Los Angeles Regional Water Quality Control Board

SUBJECT: REVIEW OF RESPONSE PLAN AND REMEDIAL TECHNOLOGY EVALUATION – PURSUANT TO CALIFORNIA LAND REUSE AND REVITALIZATION ACT, AND HEALTH AND SAFETY CODE SECTION 25395.94

SITE: FORMER CHEMOIL REFINERY AT 2020 WALNUT AVENUE, SIGNAL HILL, CALIFORNIA 90755 (SCP NO. 1391, SITE ID NO. 2040510)

FIGURE 1

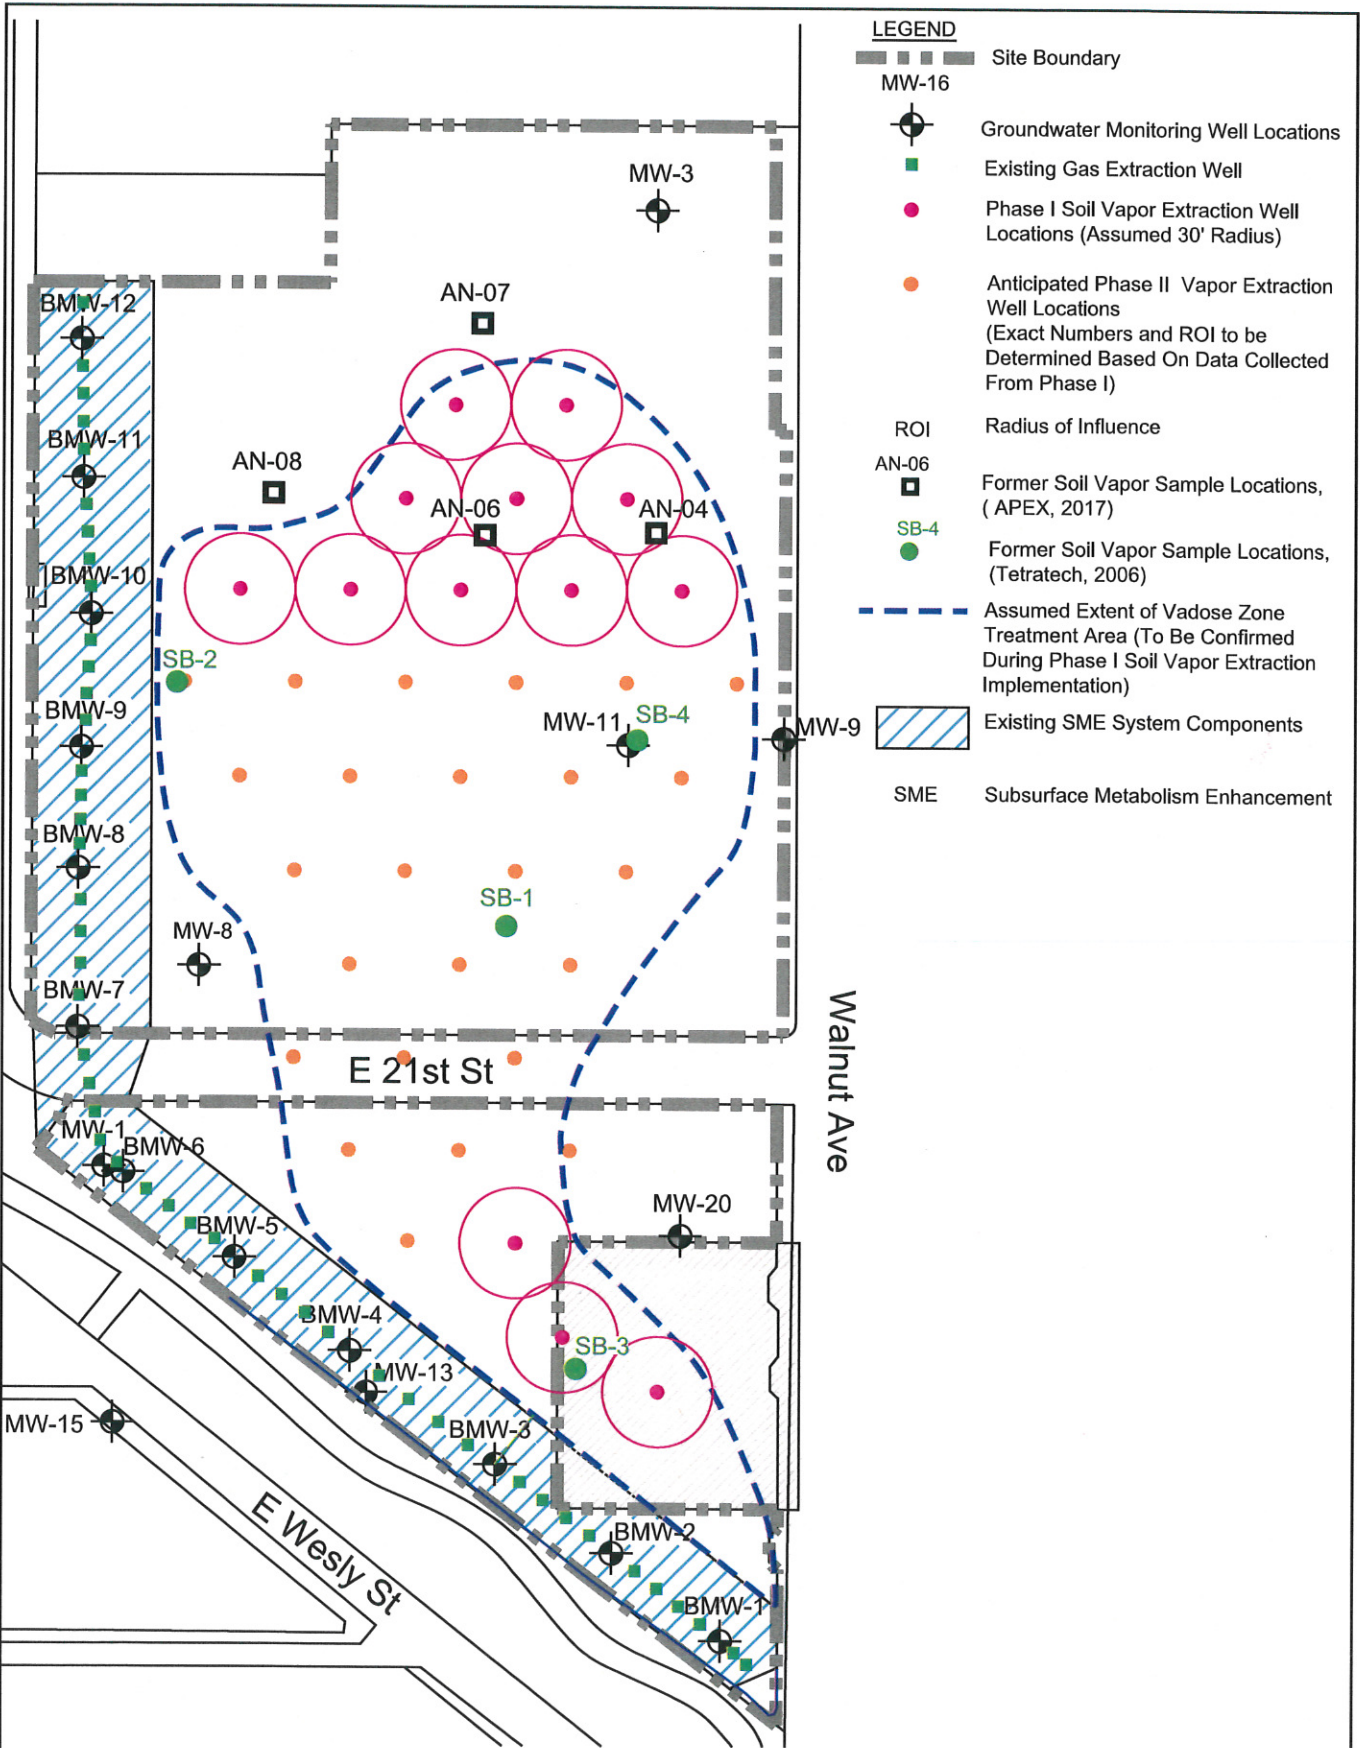
- Soil Vapor Extraction (SVE) system, Phase I (See Figure 1)
 - Installation of 13 SVE wells; 10 wells on Northwest parcel and 3 wells on the Southwest parcel.
 - Influent and post-treatment effluent vapors will be collected monthly and sampled for TPHs and VOCs.

4. The reports documenting the pilot tests of the SVE system and Air Sparging system. These reports are due on or before **February 15, 2018**. Based on the performance of the pilot tests, implementation of the full-scale remedial systems may be required, including submission of quarterly remedial progress reports.

FIGURE 2

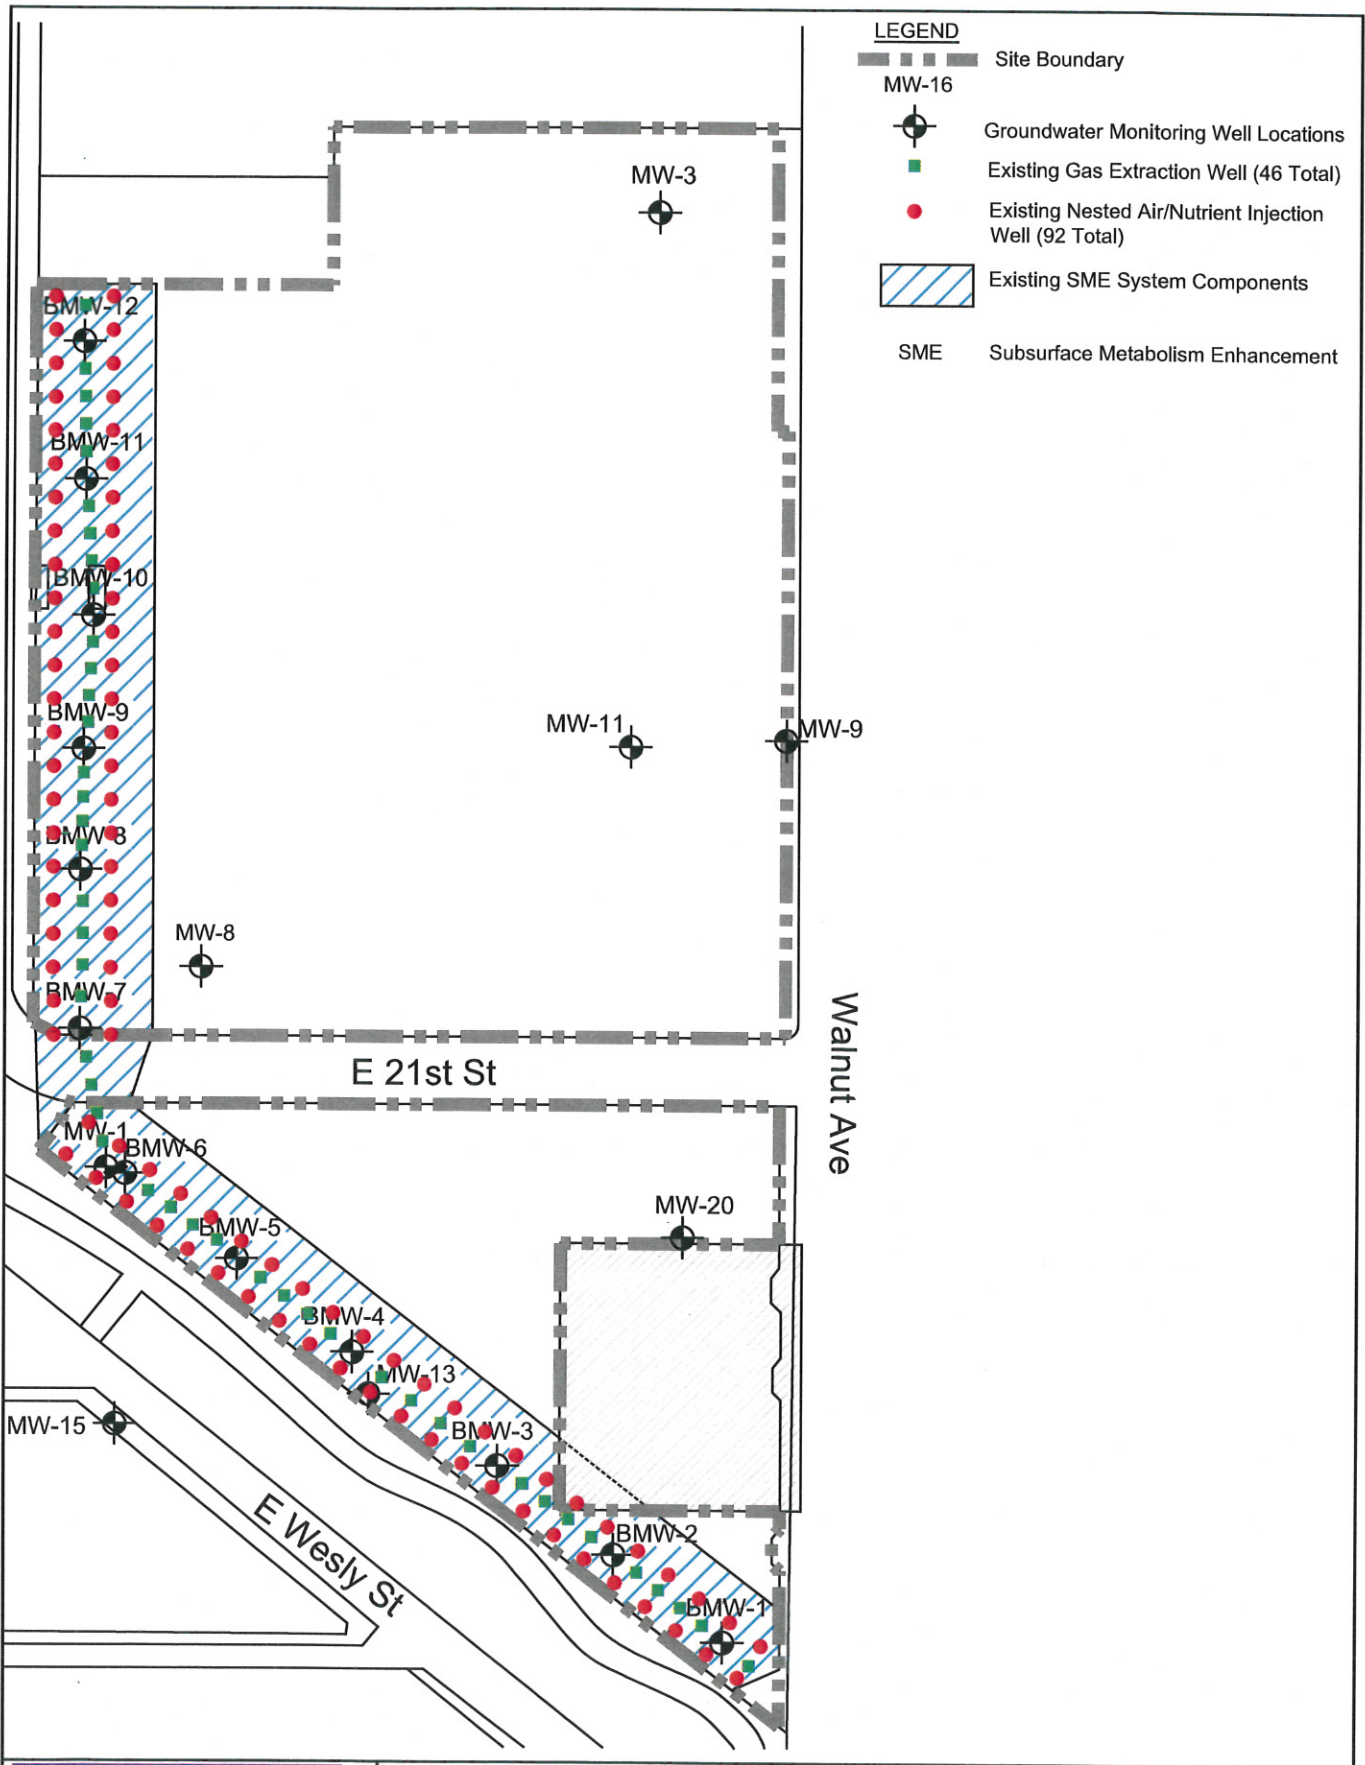
- Air Sparging System (See Figure 2) to replace the current in-situ subsurface metabolic enhancement (SME) system
 - Installation of 92 nutrient and air injection points at approximately 6 to 8 feet below groundwater level.
 - Installation of 46 extraction wells with five-foot screen intervals at approximately 5 feet above the groundwater level.
 - A pilot study will be performed to determine the radius of influence of the air sparge points.
 - Vapors extracted from the exaction wells will be routed to the SVE system.
- Liquid Non-Aqueous Phase Liquid (LNAPL) Removal
 - Two LNAPL plumes have been detected in the Northwest and Southwest parcels (See Figure 3).
 - Installation of LNAPL recovery wells and a subsurface aqua-phobic belt skimmer system within each of the LNAPL plumes.

FIGURE 4

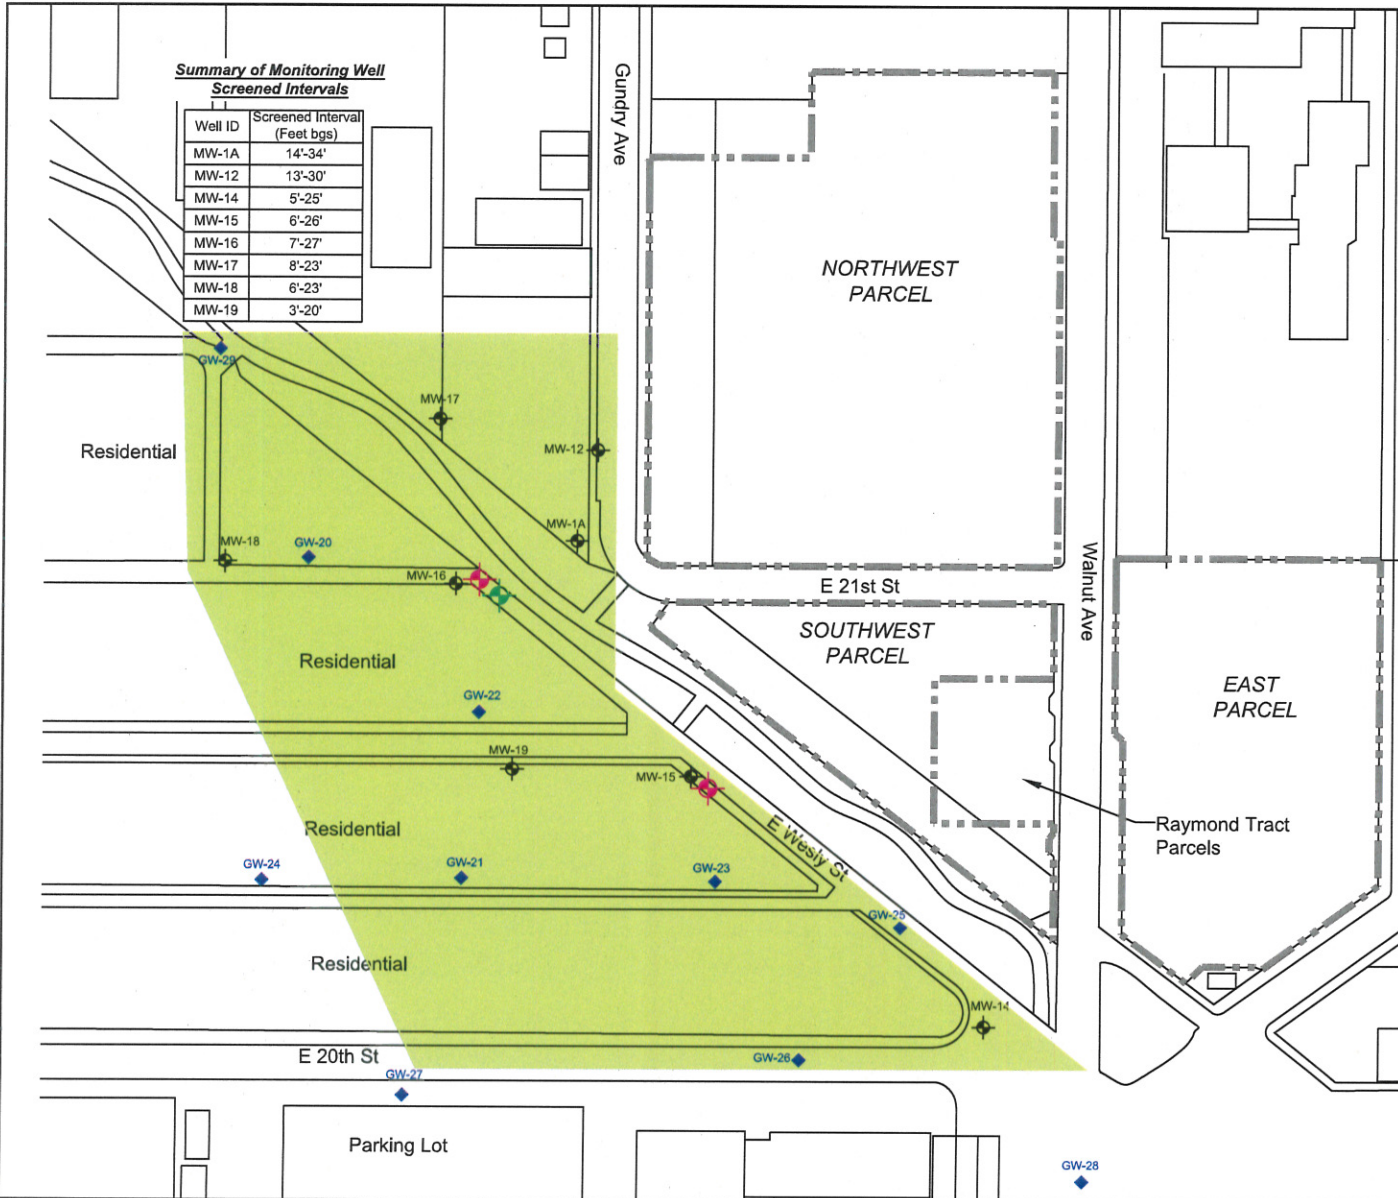
- The current off-site groundwater monitoring well network consists of eight (8) monitoring wells (MW-1A, MW-12, and MW-14 through MW-19) to monitor off-site migration of TPHs and VOCs.
- Installation of three additional groundwater monitoring wells west of the Air Sparge system (See Figure 4). Two wells will be screened from 55 to 65 feet below ground surface (ft bgs) and one will be screened from 75 to 85 ft bgs.
 - Results from the three new wells will be analyzed and determined if they will be added to the semi-annual groundwater monitoring program.
- All wells will be analyzed for VOCs, TPHs, and semi-VOCs to ensure there is no risk to downgradient receptors.

1. A well installation report for the three MNA groundwater monitoring wells is due on **January 15, 2018**.
2. Continued submission of semi-annual groundwater monitoring reports. The next groundwater monitoring report for Second Half of 2017 is due on **January 15, 2018**. The three new MNA groundwater monitoring wells should be incorporated into the semi-annual groundwater monitoring program.
